802.3dj D2.2

Comment Resolution

Common Track

Matt Brown (Alphawave Semi), 802.3dj Chief Editor

Figure 178B-10—Training control state diagram

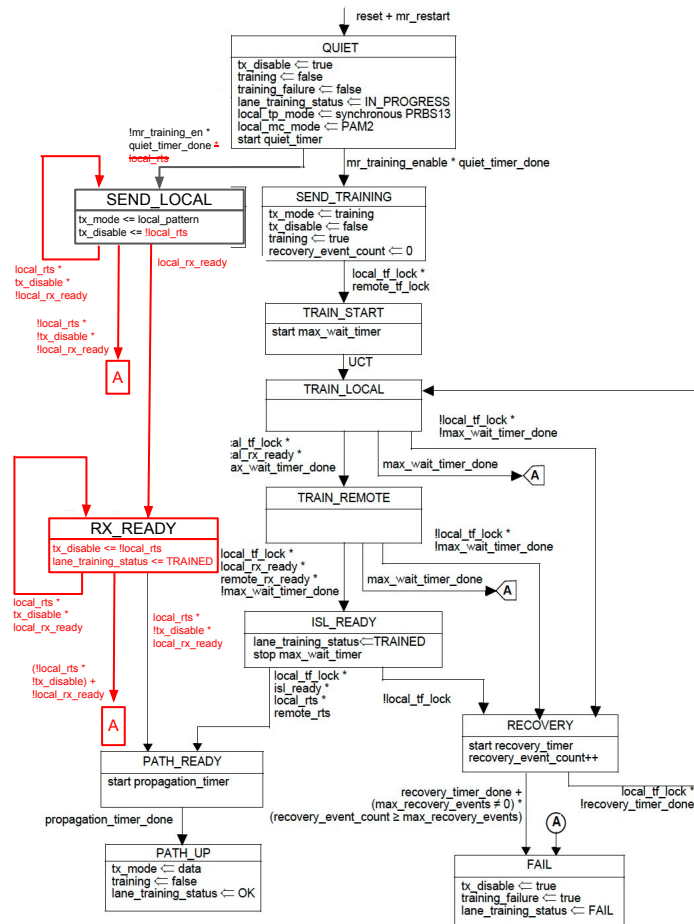
CI 178B	SC 178B.8.3.5	P889	L 10	# 344
Slavick, Jeff				
Broadcom				
Comment Type	TR	Comment Status	D	State diagrams (CI)
D2.1 comment #463 brought up an issue with local pattern mode. Nothing was changed in the resolution to address that local pattern mode. A potential fix was supplied on slide 22 of https://iee802.org/3/dj/public/25_09/slavick_3dj_02a_2509.pdf but this may be a larger change than are necessary.				
SuggestedRemedy				
In Figure 178B-10 make the following changes: Remove local_rts as a condition to enter SEND_LOCAL from QUIET Change the assignment of tx_disable to be ~local_rts in SEND_LOCAL add a recirculation from SEND_LOCAL to SEND_LOCAL when local_rts * tx_disable add a transition from SEND_LOCAL to QUIET when !local_rts * !tx_disable Update the transition from SEND_LOCAL to PATH_READY to also require !tx_disable				
Proposed Response	Response Status W			
PROPOSED ACCEPT IN PRINCIPLE. Resolve using the response to comment #222.

CI 178B	SC 178B.8.3.5	P889	L 12	# 222
Ran, Adeo				
Cisco Systems				
Comment Type	TR	Comment Status	D	State diagrams (CI)
<p>An apparent issue in the Training control state diagram (Figure 178B–10) is that, if mr_training_enable is false, then lane_training_status can only have the values (IN_PROGRESS, OK, FAIL). It is never set to TRAINED. This means that the interface-level training_status cannot be set to READY, only to OK; the READY value is never propagated across the service interface. This might interfere with the path startup procedure when some of the ISLs have training disabled.</p>				
<i>Suggested Remedy</i>				
A presentation with more detailed analysis and a proposal is planned.				
Proposed Response	Response Status W			
PROPOSED ACCEPT IN PRINCIPLE.				
Pending review of the following presentation and CRG discussion.				
<URL of presentation>

The changes to Figure 178B-10 on slide 7 of both presentations (shown on the right) addresses both comments.

We propose updating Figure 178B-10 as shown here.

Figure 121-9—Illustration of the mask of the sinusoidal component of jitter tolerance

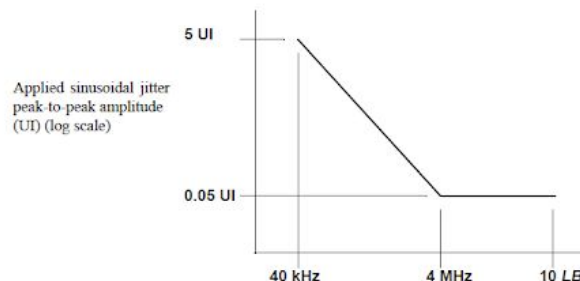
The quality of the jitter tolerance (clock tracking bandwidth) for the TXSEH functional receiver is unbounded. The only constraint is that it complies with (i.e., exceeds) the receiver characteristics in Table 180-8. Care is being taken to properly calibrate the vertical noise but no consideration is given for jitter (horizontal noise). A real receiver is required only to support a clock tracking bandwidth of 4 MHz based on jitter tolerance mask specified in 121.8.10.4. If the TXSEH functional has a tracking bandwidth much higher than 4 MHz then it would permit transmitters with excessive low-frequency jitter to pass.

Specify that the jitter tolerance of the TXSEH optical receiver (ORx) shall minimally comply with the jitter tolerance mask defined in 121.8.10.4 particularly for jitter frequencies 4 MHz and lower.
